## Stryker 3313 - Plumbing Vent thru Roof

### Description

There is a possibility that the vent was not completed inside the wall to extend through the roof.

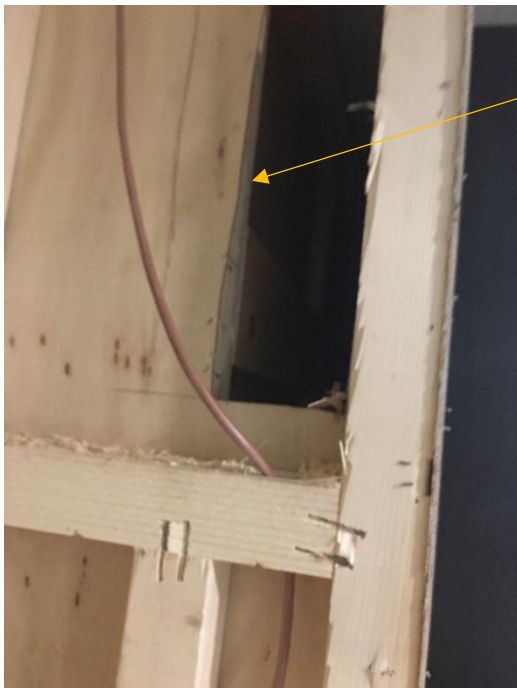
- Remove the ceiling trim.

Same as with the trim use caution as to not damage the roof trim.

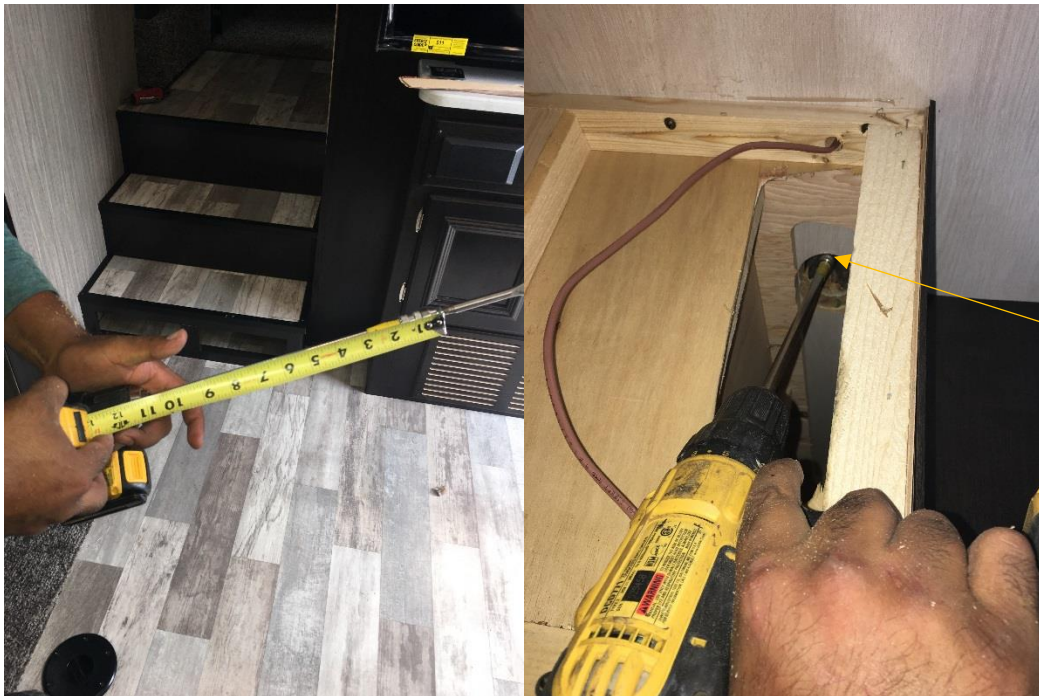
- Using a router cut hole in inside panel. Being careful not to cut into bath wall.

Using a router cut out your opening, use caution and do NOT cut into the adjacent walls.
